24 March 2020

Our ref: 12502848

## **Deepdell North Stage III Project - Receiving Water Quality Analysis Response to Otago Regional Council RFI**

**Figure 2-1 AWBM calibration**

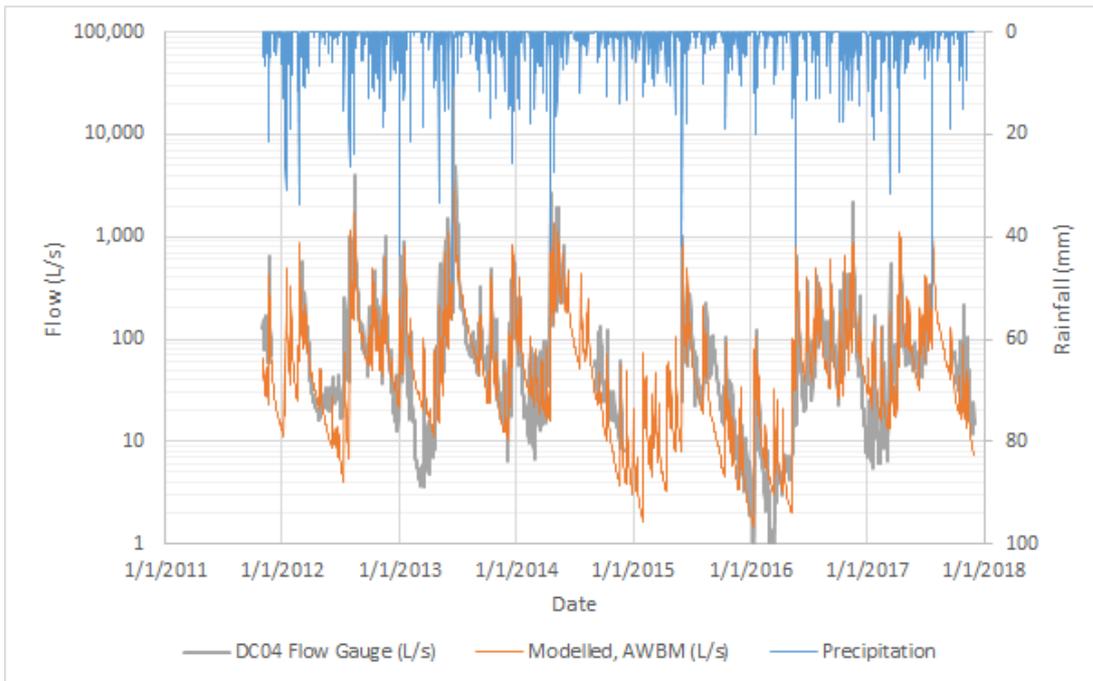
*(a) Provide a presentation of the 6.5 year hydrological calibration period (graphically)*

The full model calibration is graphically presented in Figure 2-1 following. The blank sections in the gauge data indicate where the gauge was not in service.

Note that the calibration of the model was done over the full period, Figure A-4 presented in the report was shown as an example. The period for graphical representation shown was selected based on it being the most recent and including a more continuous period of gauge data.

**Figure 3-1 Sulfate concentrations with flow in Deepdell Creek**

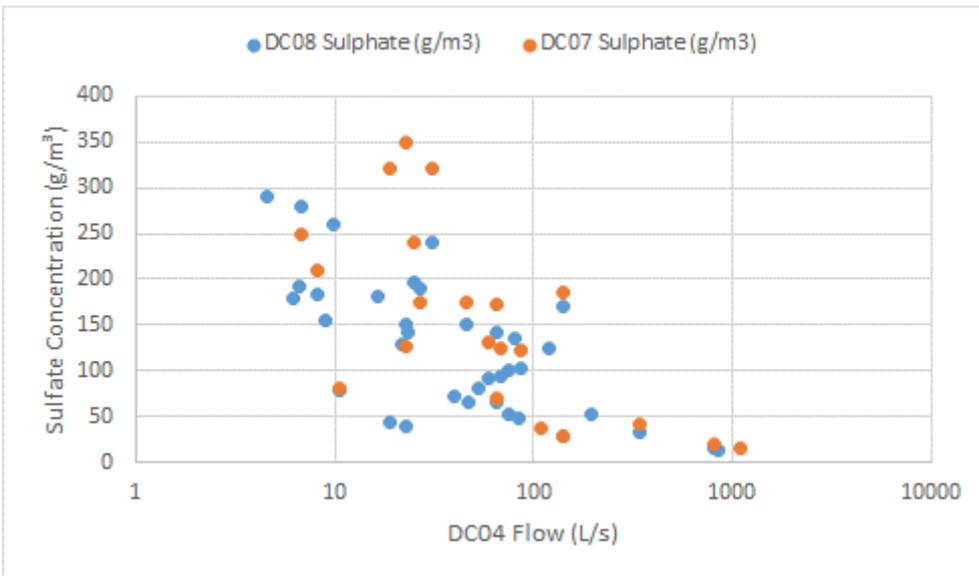
*(a) Provide context on why the normal distribution was utilised versus a DWC/EMC approach, and how the 20% standard deviation applied to these distributions captures the range of observed concentrations from monitoring data.*

At the key sampling locations, correlation between flow and concentration can be observed, with a typical trend of decreasing concentration with increase in flow. For example, DC07 and DC08 sulfate concentration compared with DC04 flow rates as shown in Figure 3-1. These sampling locations are fed by multiple affected and non-affected catchments so are not suitable for defining source concentrations, however, it does indicate that the lower flow regimes are critical for compliance and model development considered this.

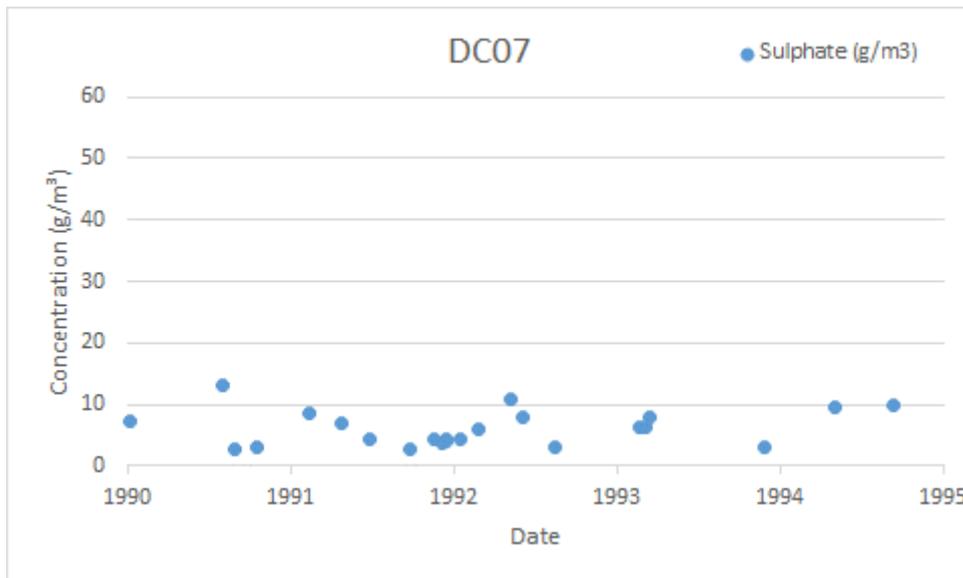
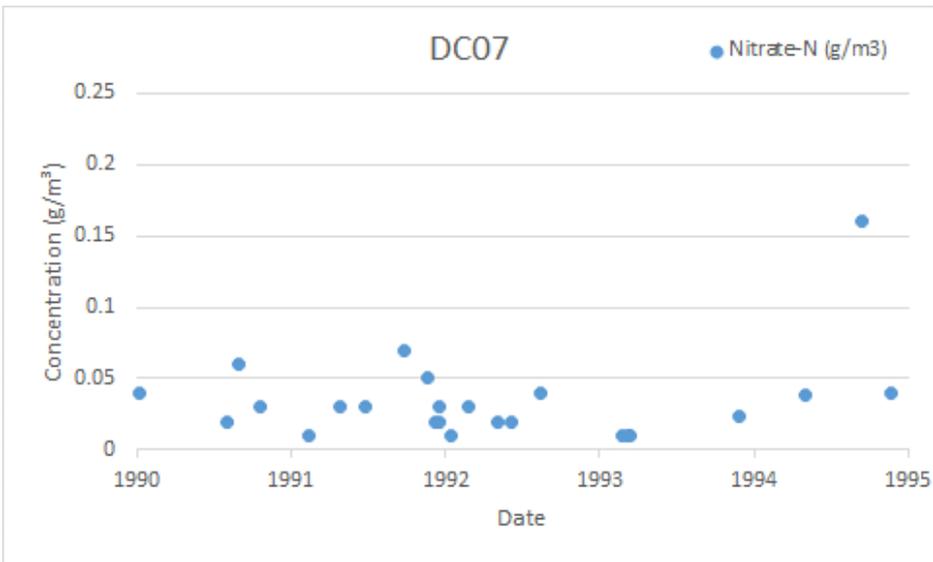
*(b) Describe how the Deepdell Creek and wider Shag River catchments outside of the mining domain were simulated for water quality. This may include describing any landuse mapping that was undertaken, or if 'natural' water quality modelling parameters were applied to any landuse outside of the mining footprint.*

The natural water quality inputs are based on measurements taken at DC01, where there were minimal impacts from mining activities prior to works at Coronation WRS (Figure 3-8). Consideration was also given to observations at DC07 prior to 1995 where DC01 data was sparse for a given parameter (Figure 3-9). Further sense checks considered measured values within the Shag River to check the potential that mass loads from the upper Shag catchment is influencing the concentrations above what would be expected from the natural proxy data applied. Considering the sulfate example, natural proxy data applied a conservative mean value of 24 g/m<sup>3</sup>, such that the upper range of observed sulfate concentrations is captured within the normal distribution (Figure 3-8). Note that the high levels measured at DC01 since 2015 were disregarded in this analysis as these are shown to be caused by works at the Coronation WRS.

Only four data points for Nitrate were available at DC01 prior to 2015, thus early measurements at DC07 (Figure 3-10) were applied as the baseline natural catchment inputs. The calculated mean of 0.034 g/m<sup>3</sup> was elevated to 0.05 g/m<sup>3</sup> such that the 95<sup>th</sup> percentile was appropriately captured within the modelled normal distribution.

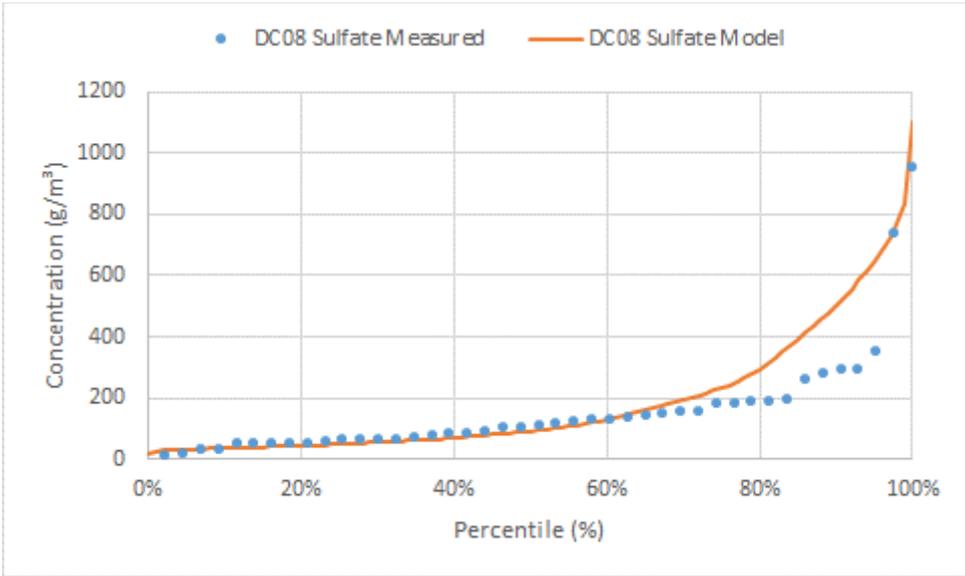
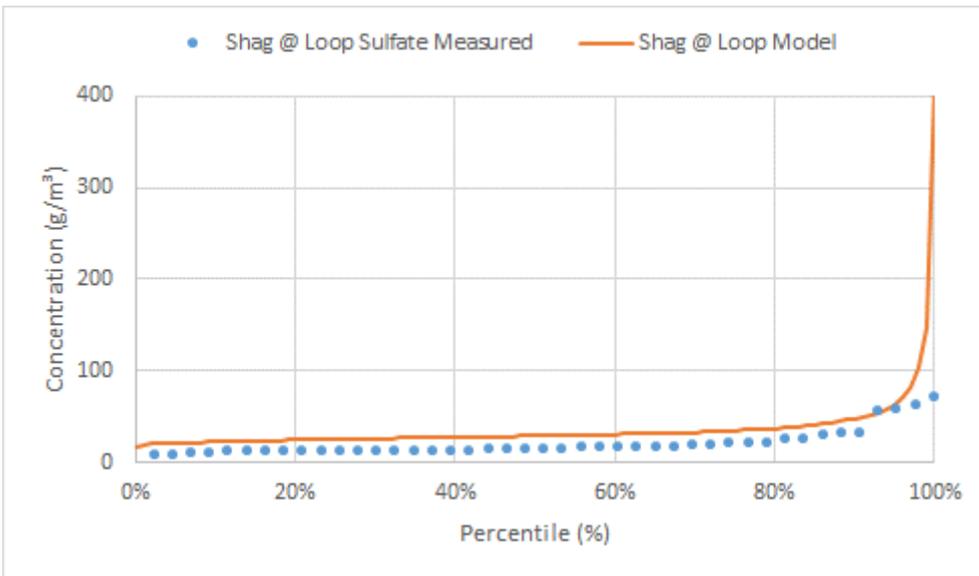
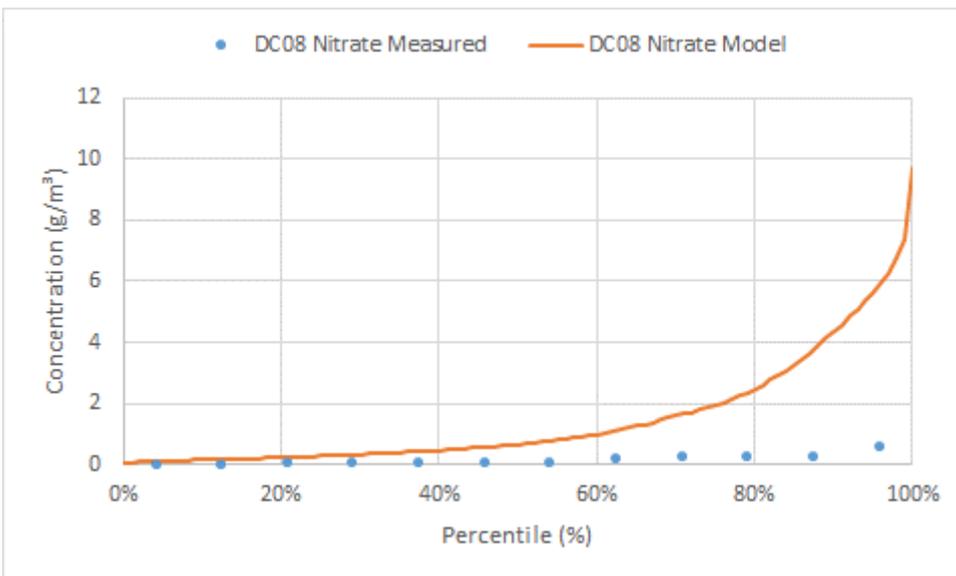
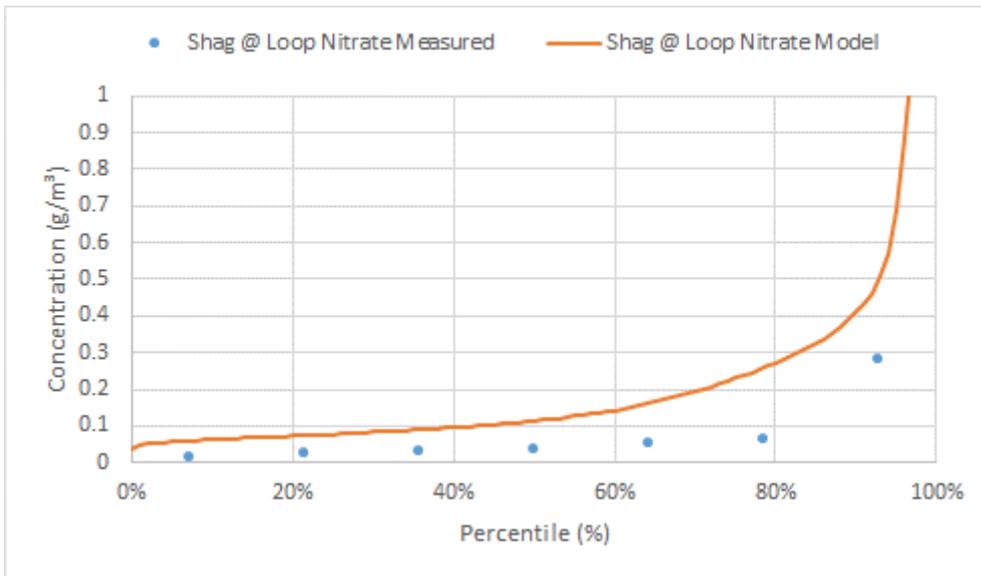
*(c) Describe (and present) how the baseline water quality model was calibrated for Deepdell Creek and Shag River based on the current state (including current mining operations) in order for scenarios of the Deepdell North Stage III project to be assessed.*

The water quality model was validated by running the model based on existing mine state over the previous 3.5 years (2015-2018) and comparing model outputs with measured data. Where the comparison was found to be inadequate water quality inputs were adjusted to suit. The validation was run with actual measured rainfall and statistical water quality inputs

Figure 3-11 and Figure 3-12 present the comparison of measured and modelled sulfate levels at DC08 and Shag River at Loop Road sites respectively. Figure 3-13 and Figure 3-14 present the comparison of measured and modelled Nitrate levels at DC08 and Shag River at Loop Road sites respectively. In each case the model is shown to conservatively represent concentrations at the higher percentiles where exceedance of consent conditions could potentially occur.

**Figure 4-1 Highlay Creek catchment**

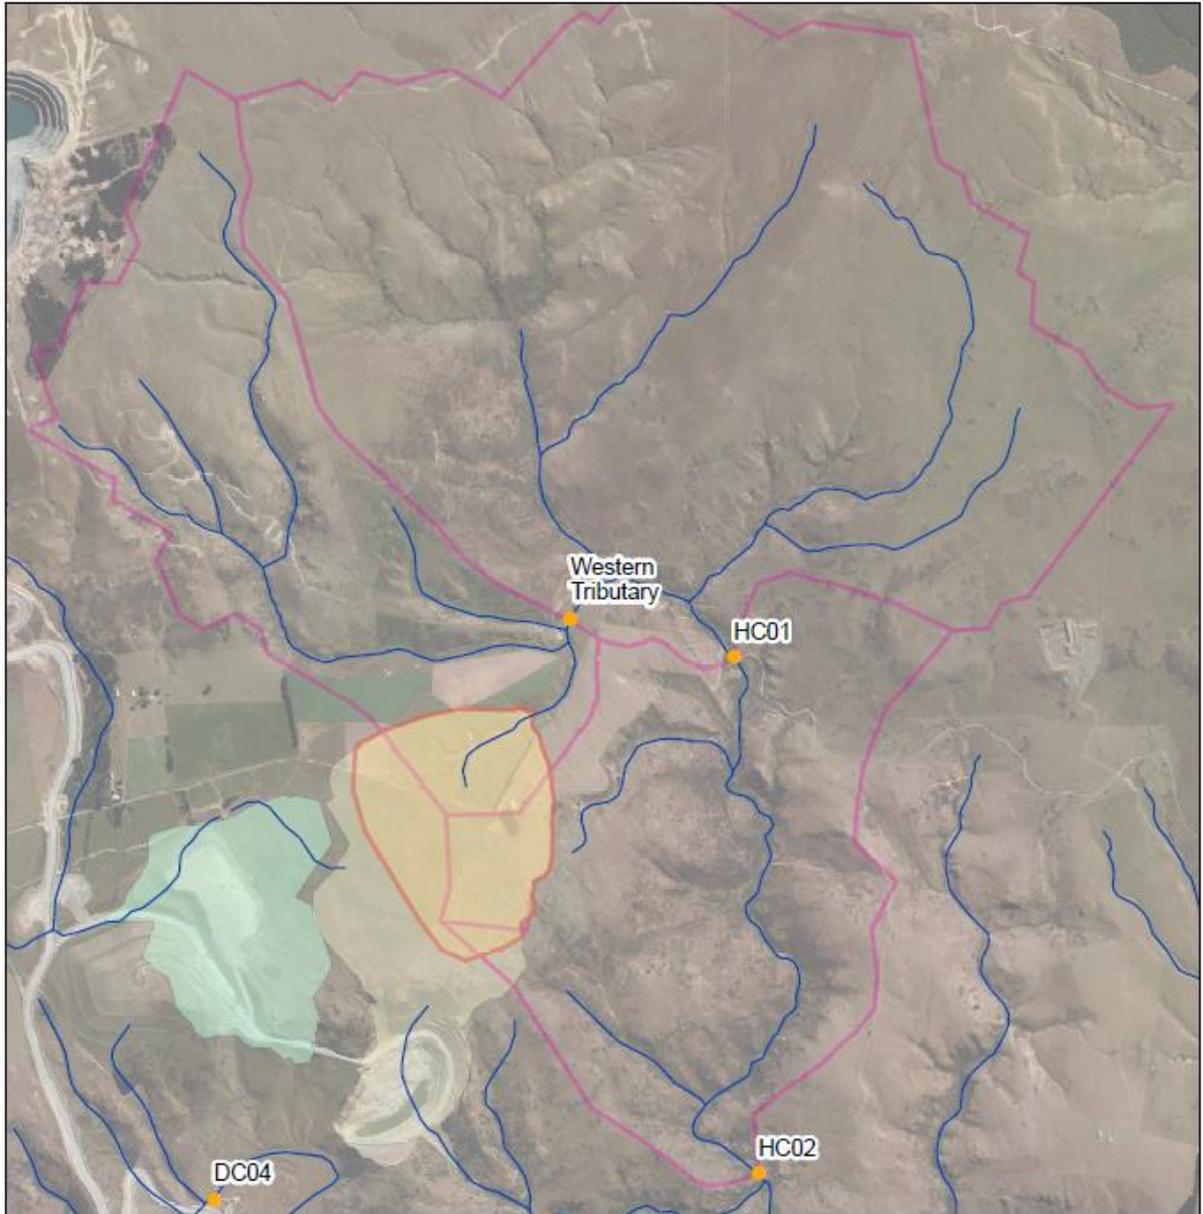
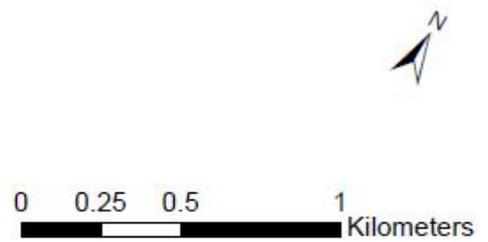
*Provide the likely contaminant concentrations in both Highlay Creek and its Western Tributary (location shown in appendix 1) and proposed water quality standards for these creeks that can be applied in consent conditions. For nutrients, these standards should be set to control plant growth rather than toxicity.*

Contaminant concentrations within Highlay Creek and its Western Tributary were not modelled as a discrete point within the modelling completed for the initial water management report. A predictive analysis has been conducted to assess the water quality at three locations including, the Western Tributary and the existing monitoring points of HC01 and HC02, as shown in the following figure.
